# CITY OF DELRAY BEACH

### CITY COMMISSION STAFF REPORT

#### 46 Marine Way

Meeting	File No.	Application Type
July 15, 2025	2024-133	Certificate of Appropriateness, Relocations, Variances, & Waivers

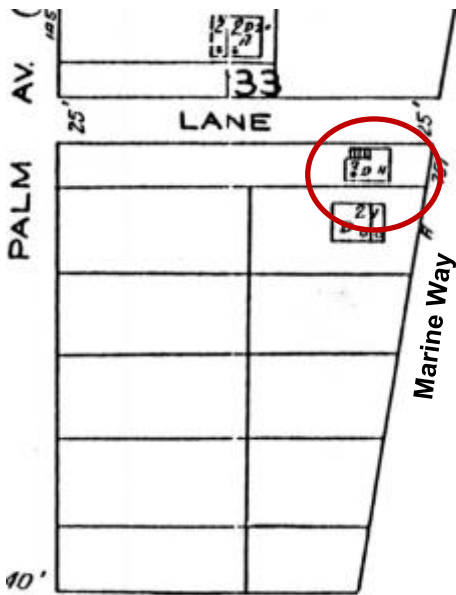
With respect to **Height**, although the proposal meets the 35 feet maximum height requirement for the zoning district, there is concern that the three-story addition is not visually compatible with the Marine Way historic streetscape. While it is anticipated that some of the third story will not be visible from the adjacent right-of-way (when viewed from the front of the property) it will be visible from the adjacent properties to the south, west, and north and from a distance further away in the historic district. Having particular impact on the adjacent historic property to the south, as the addition is proposed to be 42 feet tall measured from grade to top of roof of the third floor (the proposed 35 feet maximum overall height is measured from finished floor elevation, and such is permitted by the LDRs within FEMA flood zones). Existing historic/contributing residential structures within the Marina Historic District are one or two-stories. The proposal also does not meet the LDR requirements for Building Height Plane (BHP), with a large portion of the new addition proposed within the “no build zone” (a waiver to this standard has been requested and is analyzed further in this report).

There is concern with the proposed **Proportion of Openings (Windows and Doors)**, in that the rhythm and placement of the windows on the existing structure may no longer reflect the window pattern of the historic structure. Also, the placement of windows/doors that correlate to the use and floor levels within the building creates an array of window placements on some of the building elevations. There are concerns that the proposed window sizes could create a conflict with the transition of the original structure to the new addition, but their placement does aid in providing distinction between floors. For example, the original sliding glass doors on the rear/west side of the guest cottage are being retained at the 3<sup>rd</sup> floor level and appear out of place at that plane. The existing awning style window on the same elevation is also proposed to be retained, where it would be standard practice to replace it with a single-hung window. Consideration could be given to modifying the sliding glass door opening to accommodate a balcony or to incorporate the use of standard windows that are in line with the design of other proposed windows. All of the windows on the existing residence are to be replaced with impact resistant, clear, no low-e, non-reflective, no tint glass; with nearly all of the existing openings remaining in their original location. On the south elevation, a square window is to be replaced with a single hung window.

**Waiver Request 1:**

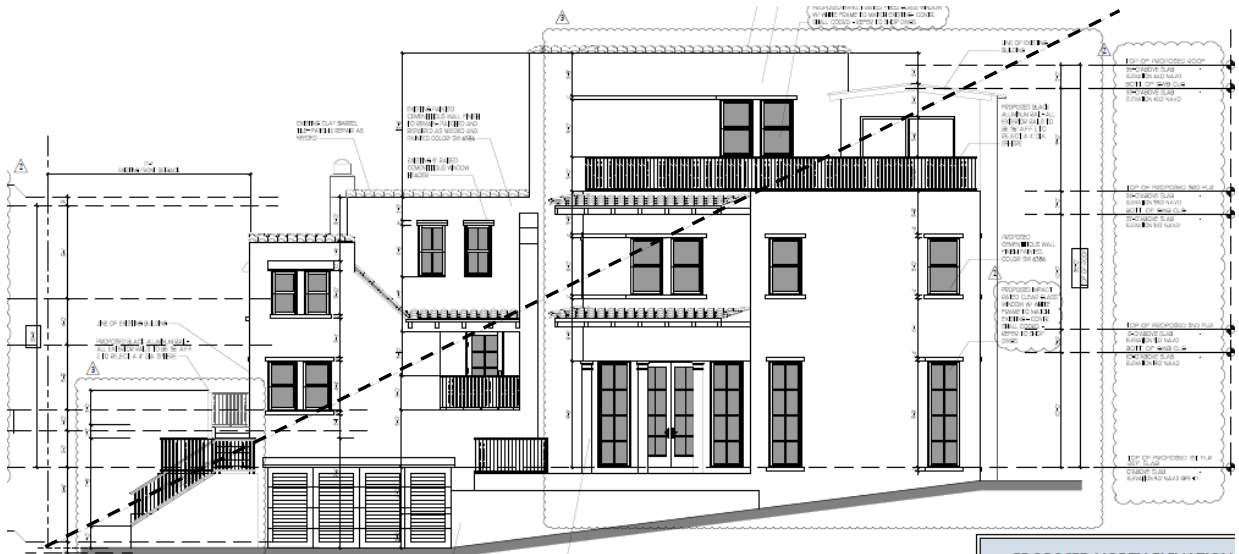
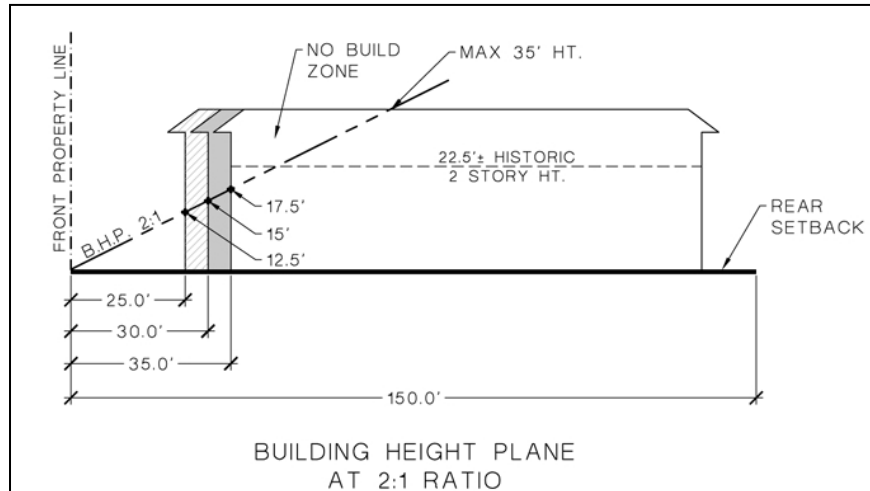
The Waiver request is to allow the addition to the front addition and existing vertically elevated structure to encroach within the required 2:1 Building Height Plane ratio.

waiver is necessary. Should the structure be elevated to a 9 feet finished floor elevation rather than a 14 feet elevation, the impact of the massing upon the area and specifically Marine Way would be reduced. Additionally, it is important to note that the entirety of the third floor of the rear addition and a small portion of the second floor of the addition also fall within the Building Height Plane (BHP) area. While some accommodation may be reasonable for raising the historic structure, extending this allowance to a three-story addition that is set back from the street should be weighed. The board will need to make a determination if the waiver adversely affects the neighboring area.

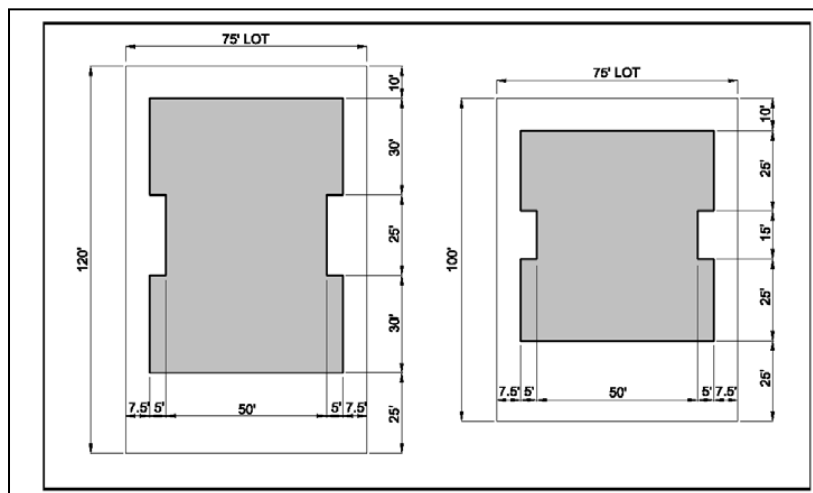
As more development occurs within historic districts, it is imperative that the historic sites and the district streetscapes remain compatible in massing and configuration to maintain the

historic setting of the district. The Marine Way area is known for flooding during storms and King tide events; thus, vertical elevation of the existing contributing structure will improve its resiliency to flooding. Elevating to 9 feet finished floor elevation is required by FEMA and the Florida Building Code. However, the proposal elevates the existing structure to a finished floor elevation of 14 feet, 5 feet above the minimum requirement to accommodate a ground level garage underneath the historic residence.

While three-story structures do exist within the historic district, they are limited to newer built structures. The subject property is smaller than the minimum requirements for a lot in the R-1-A zoning district, so minor constraints on the square footage that can be built on the property exist. However, it is noted that the proposal is for a 3,814 sq. ft. addition to the front and rear of the 1,328 sq. ft. historic structure and 296 sq. ft. pool house. The proposal will result in a building containing 5,457 sq. ft. on the 4,972 sq. ft. lot. Smaller, non-conforming lots are common within historic districts, such was the development pattern at the time of historical development. Therefore, it is possible to construct an addition that can be considered more secondary and subordinate to the main structure. The board will need to determine if the waiver results in a special privilege and if the same waiver would be granted under similar circumstances on other property. It is noted that there are two other COA's in process for the two properties immediately to the south of the subject site.
